2025 REVISION TABLE

(To the 2024 Electric Line Extension and Service Standards)

**DRAWING 12A - POST TYPE INSTRUMENT TRANSFORMER (CT & VT)
METER INSTALLATION (FROM A CT CABINET)**

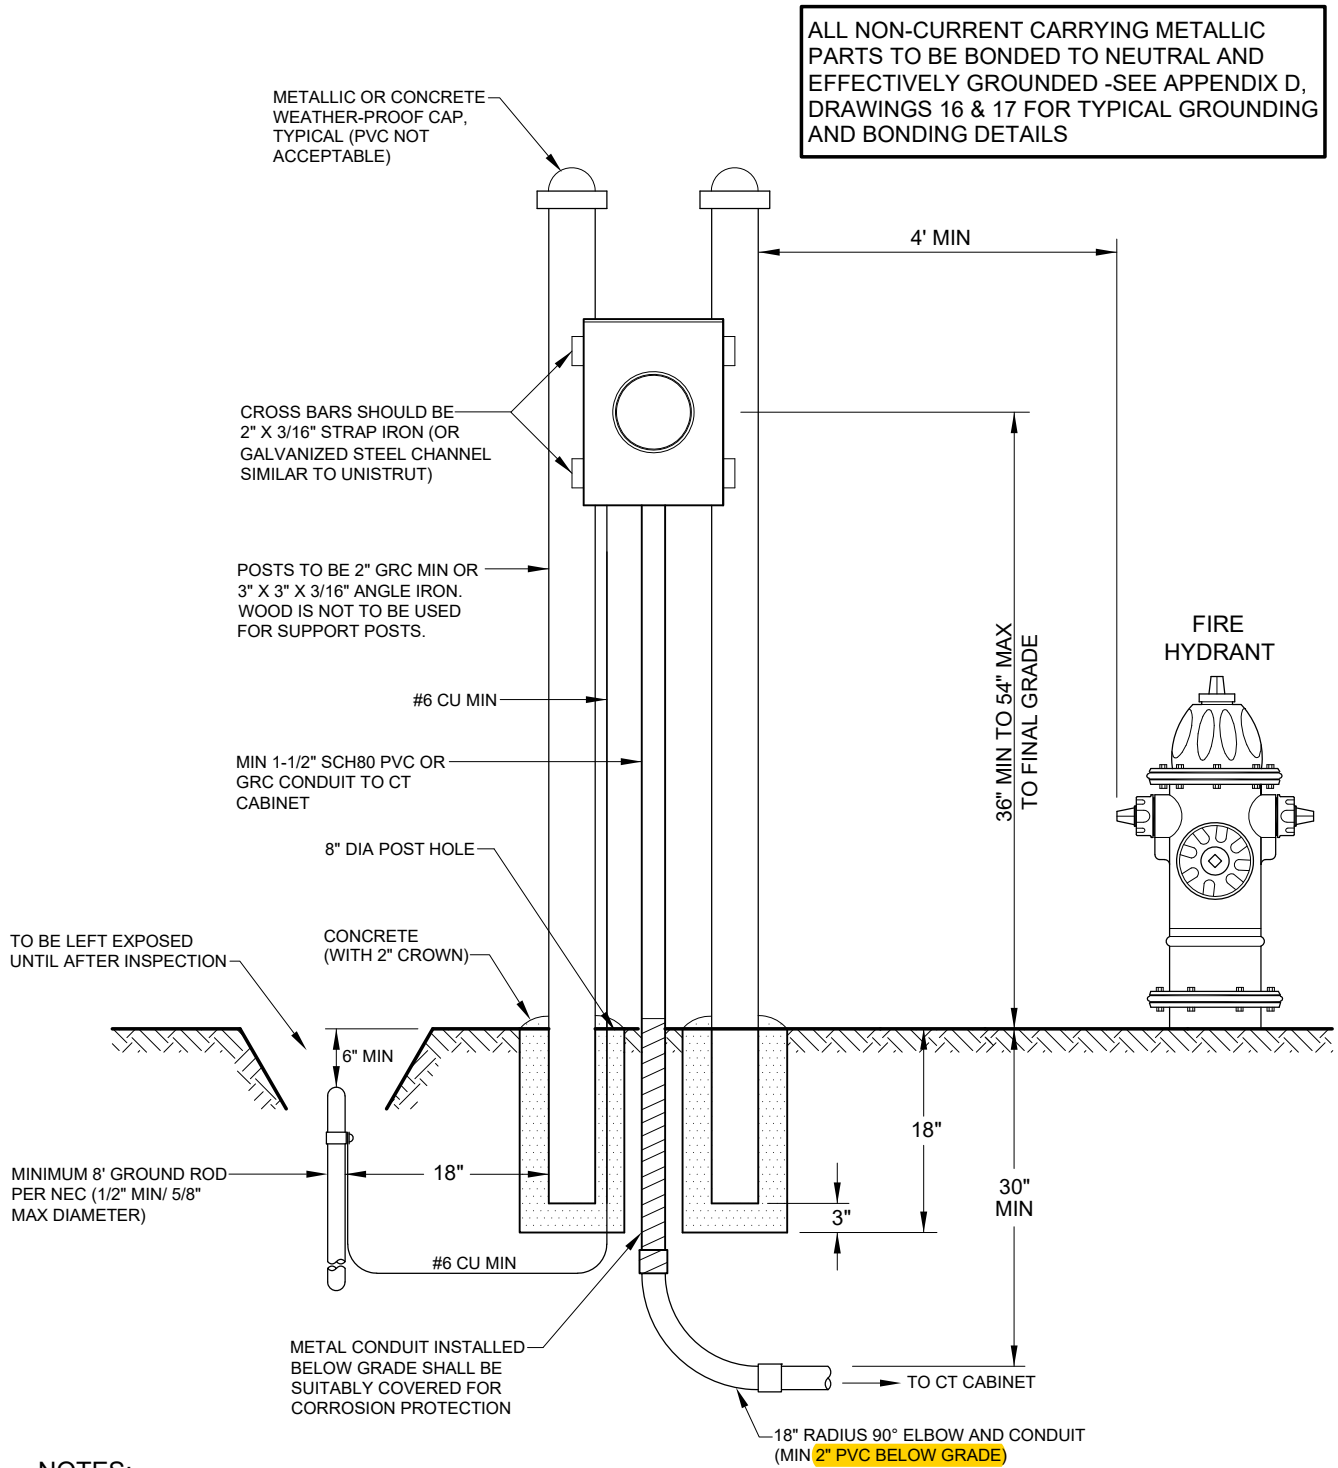
Christopher Sine, -Minimum conduit size for above ground vs below ground CT metering conduit. -Changed Maximum CT Conduit run length from 35' to 20'.	Appendix D, (Various)	(Various)	-Appendix D, Drawings 12A, 12B, & 13: 18" RADIUS 90° ELBOW AND CONDUIT (MIN 2" PVC BELOW GRADE) -Appendix D, Drawings 14 & 15: 1-1/2" SCH80 PVC OR GRC- 20' MAX,OR EMT- 2' MAX -Appendix D, Drawing 19: 20' MAX and note 7: The CT meter conduit shall be no longer than 20 feet (total length of conduit including all bends)
Christopher Sine, Line/ Load Side feed on Overhead vs Underground Services	Appendix D, Photo 1	PHOTO 1 – THREE PHASE CT CABINET	<u>For Overhead Services, Line Side must be on Top. For Underground Services, Line Side may be on the Bottom or Top.</u>
Elizabeth Ritchey, Clarify color options for AC Disconnect Switch	Appendix D, Photo 6	PHOTO 6 – PHOTOVOLTAIC SERVICE EQUIPMENT LABELING	Customer Provided “AC Disconnect” Placard on AC Disconnect Switch. <u>Color may be black text on yellow background or white text on red background.</u>

1. Meter to be mounted with a maximum distance (total length of conduit run including all bends) of 20' from instrument transformers (CTs & VTs), refer to paragraph 5.04e for instrument transformer conduit installation.
2. Both posts must be effectively grounded.
3. Refer to trench information, 10.1f (commercial).
4. Connect #6 copper conductor from ground rod to ground terminal inside meter enclosure; this ground is in addition to that which may be required by the Regional Building Department.
5. Provide pull line for instrument transformer (CT & VT) wire.
6. For 277/480 volt services, a VT ("VT Pack") is required.

**DRAWING 12B - POST TYPE INSTRUMENT TRANSFORMER (CT & VT)
METER INSTALLATION (FROM CT'S IN A TRANSFORMER)**

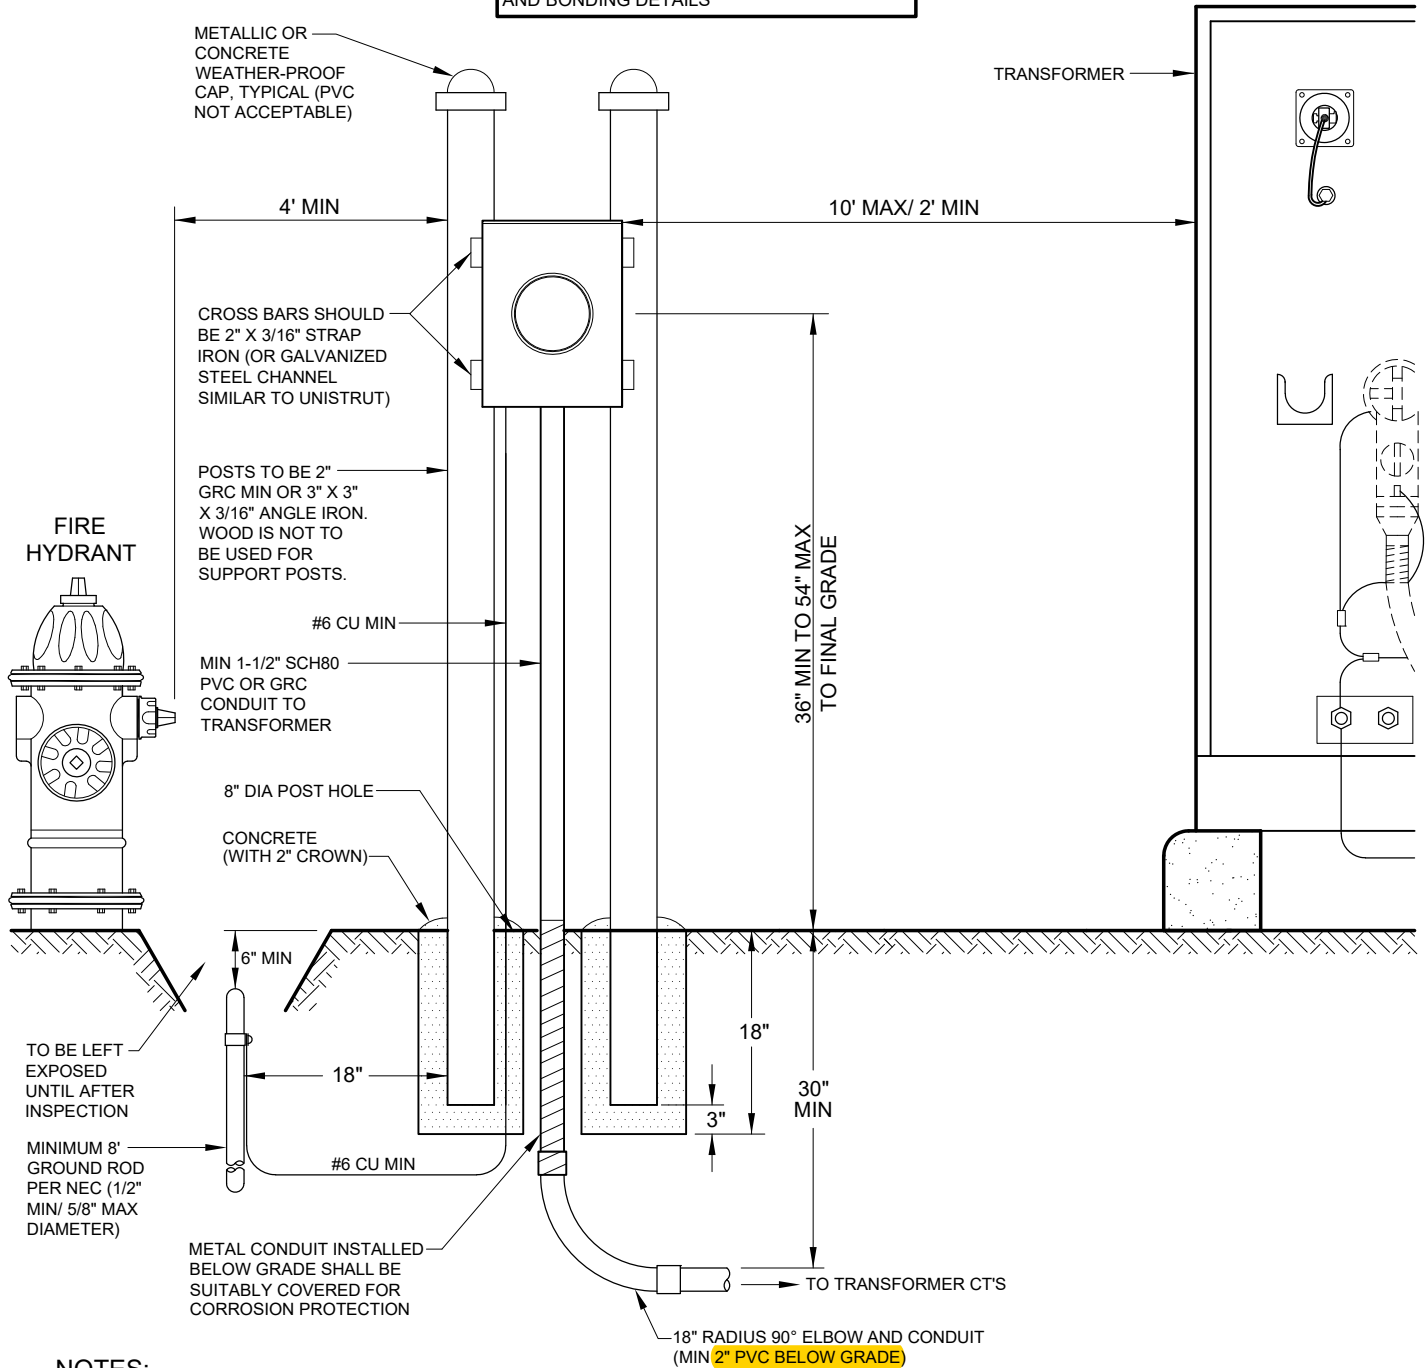
1. Meter Socket must be mounted along side or behind the transformer on a pedestal or post (unistrut or other), at least 2' but not to exceed 10' as shown. Socket location cannot be in front of the transformer or in a location that interferes with truck access. See Appendix F, 18-302 page 2 for padmount equipment clearances for working space. See Chapter 5, paragraph 5.04e for instrument transformer conduit installation.
2. Both posts must be effectively grounded.
3. Refer to trench information, 10.1f (commercial).
4. Connect #6 copper conductor from ground rod to ground terminal inside meter enclosure; this ground is in addition to that which may be required by the Regional Building Department.
5. Provide pull line for instrument transformer (CT & VT) wire.
6. For 277/480 volt services, a VT ("VT Pack") is required.

DRAWING 13 - INSTRUMENT TRANSFORMER (CT & VT) METERING INSTALLATION

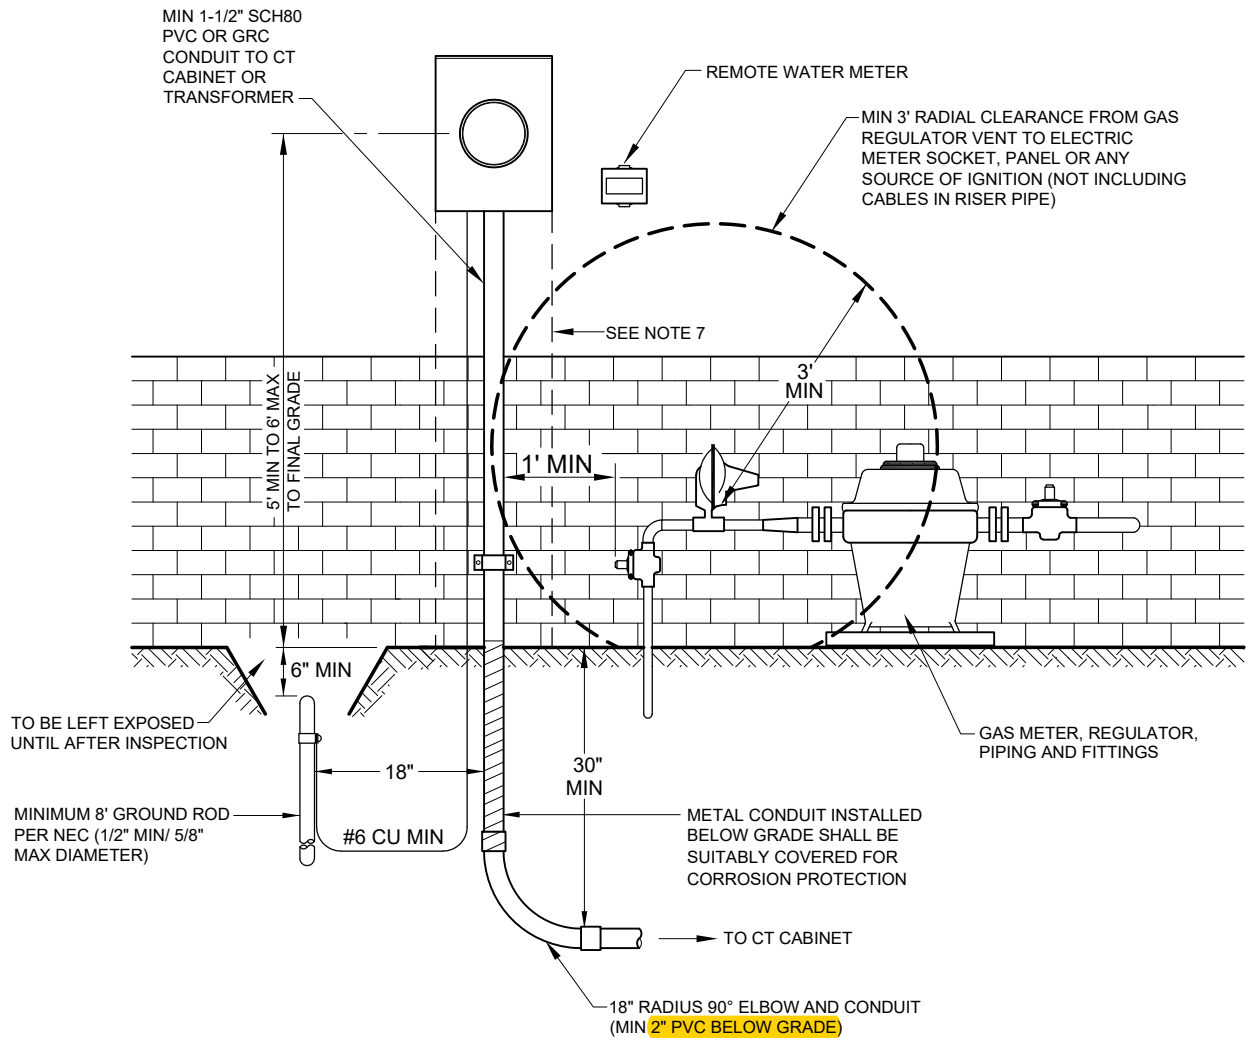
1. Meter to be mounted with a maximum distance (total length of conduit run including all bends) of 20' from instrument transformers (CTs & VTs), refer to paragraph 5.04e for instrument transformer conduit installation.
2. Conduit clamp must be above ground.
3. Refer to trench information, 10.1f (commercial).
4. Connect #6 copper conductor from ground rod to ground terminal inside meter enclosure; this ground rod is in addition to that which may be required by the Regional Building Department.
5. Provide pull line for instrument transformer (CT & VT) wire.
For 277/480 volt services, a VT ("VT Pack") is required.
6. All above ground gas piping to be installed outside of meter socket (30" minimum) clear working space.

FIGURE 1

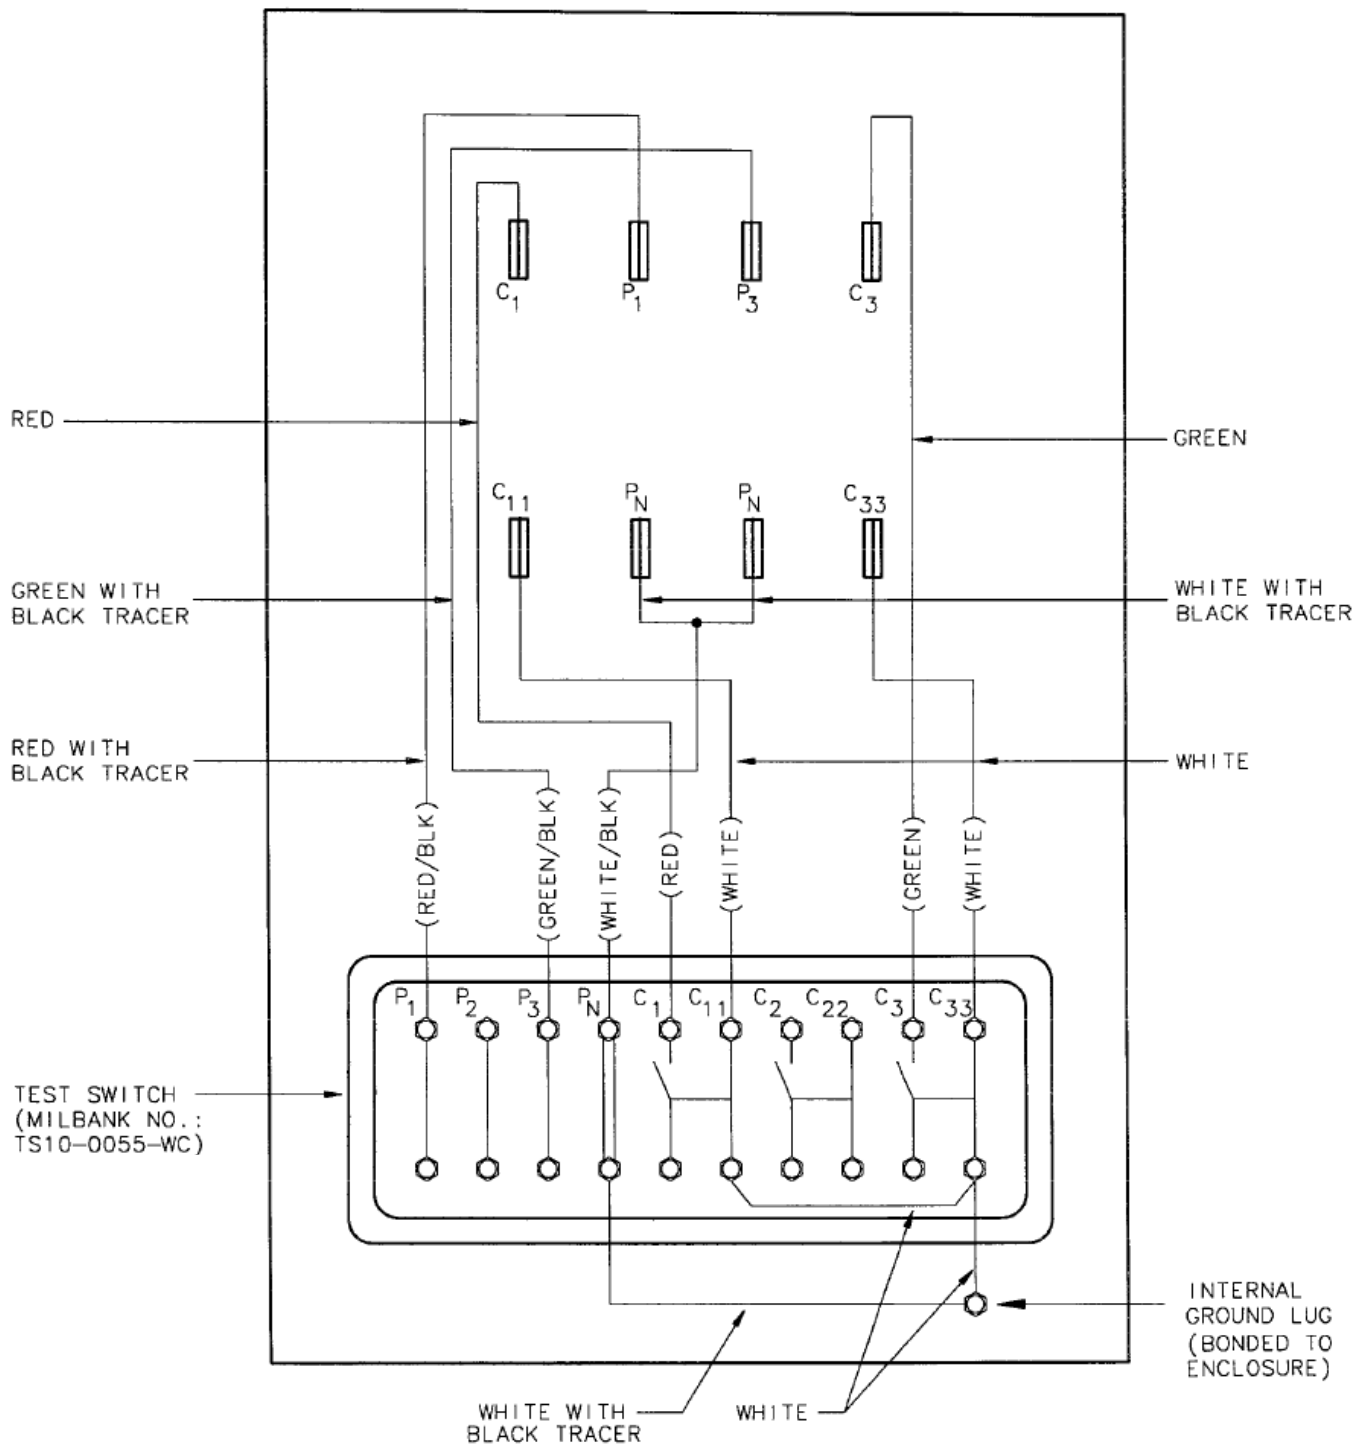
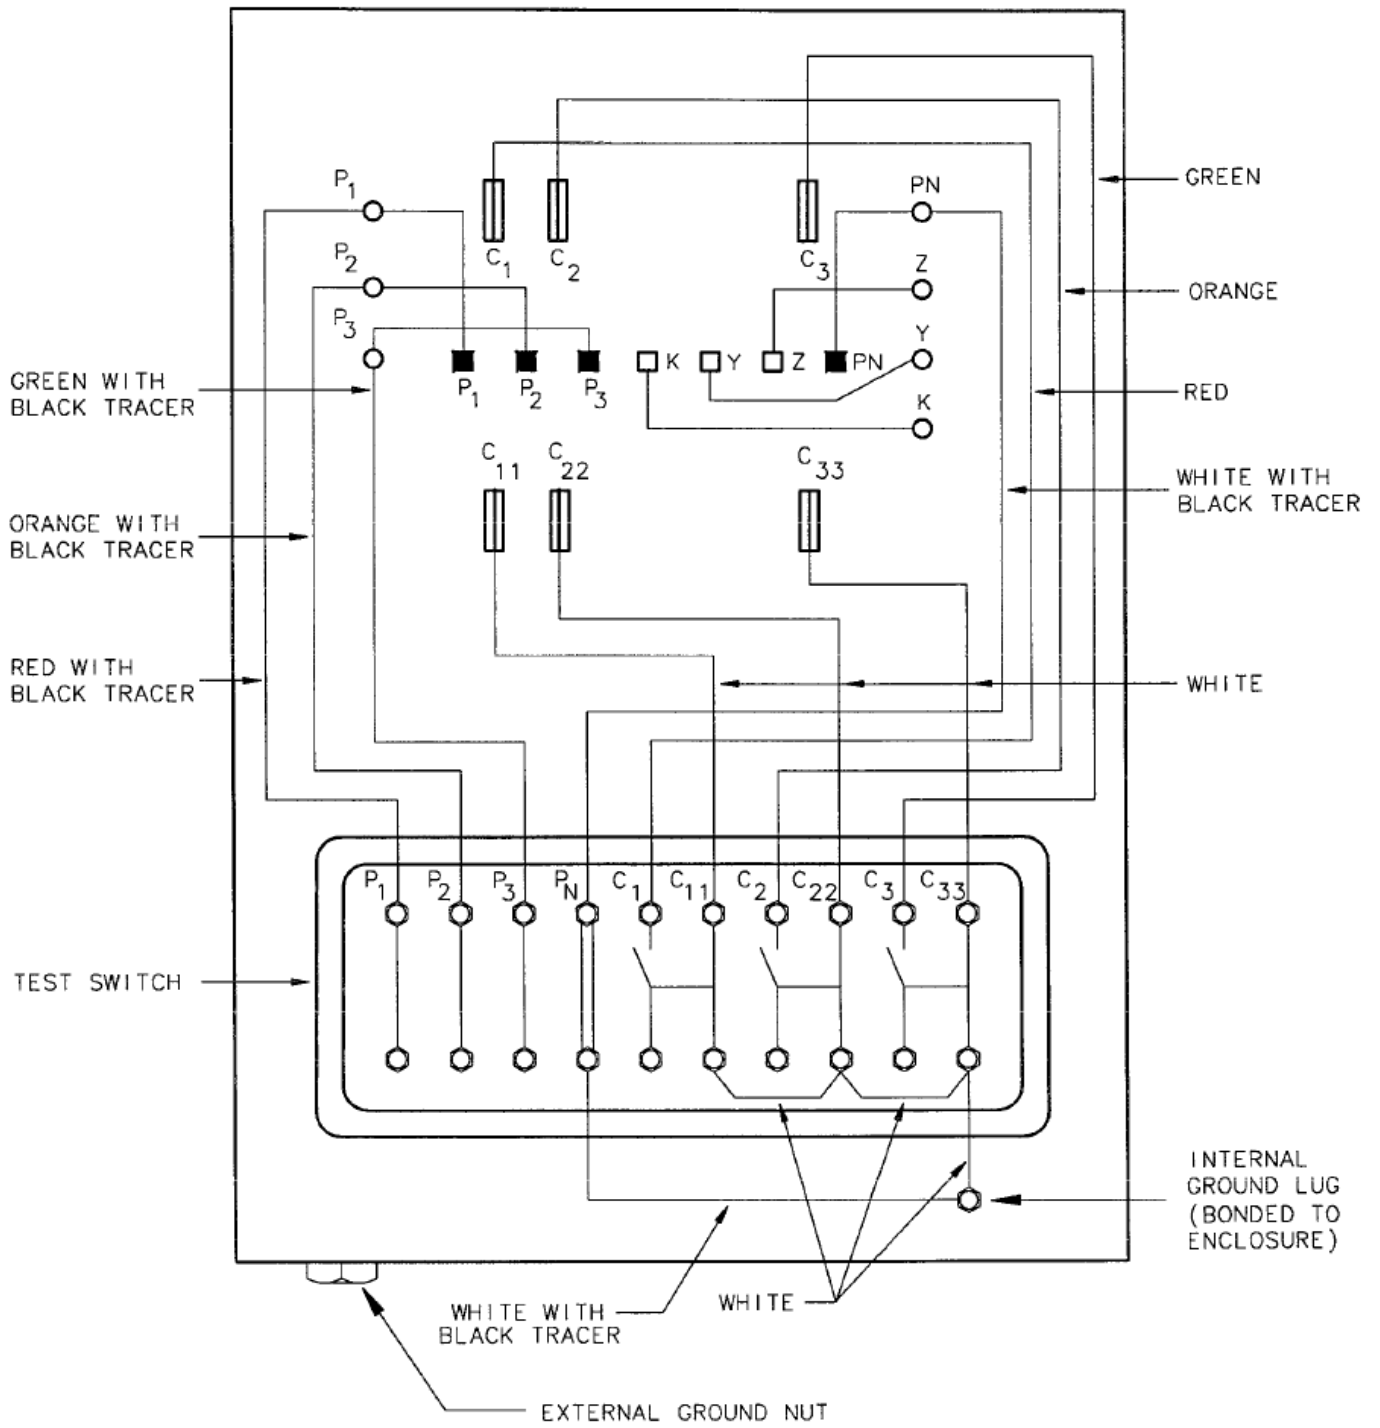
Toby Mijares, Updated specification 102-600-077	Appendix E, Material Specification	102-600-070 & 102-600-077 Socket, Meter, Prewired Test Switch, 8 & 13 Terminal, 20 Amp	Updated Material Specification 102-600-070 & 102-600-077 Socket, Meter, Prewired Test Switch, 8 & 13 Terminal, 20 Amp
Toby Mijares, Add specification 102-700-(000-001) to Appendix E	Appendix E, Material Specification	102-700-(000-001) Switch, Color Coded Meter Test – (VARIES) Connected	Add Material Specification 102-700-(000-001) “Switch, Color Coded Meter Test – (VARIES) Connected” to Appendix E.
Bill Galloway and Adrian Pereida, Add specification 193-SPP-SCA to Appendix E	Appendix E, Material Specification	193-APP-SCA Generation Power Plant SCADA Panels	Add Material Specification 193-SPP-SCA “Generation Power Plant SCADA Panels” to Appendix E.
Updated notes in reference to conformance with City of Colorado Springs Public Works specifications.	Appendix F, 11-1	Trenching, Backfill/Compaction, Concrete Mixes, & Aggregate Base Course Materials	-Deleted notes 1 & 2 and moved note 6 to note 1 position. -Revised note 1 as follows: “ <u>All work to be</u> in conformance with City of Colorado Springs Public Works specifications <u>(https://coloradosprings.gov/public-works/page/standard-specifications-manual)</u> . Refer to other authority if using state highway or county roads.”

- 2.5.3. Color coding of conductors shall be as listed below (see Figure 1):
 - (P1): A Potential – red with black tracer
 - (P2): B Potential – not wired

- 2.5.3. Color coding of conductors shall be as listed below (see Figure 1):
 - (P1): A Potential – red with black tracer
 - (P2): B Potential – orange with black tracer
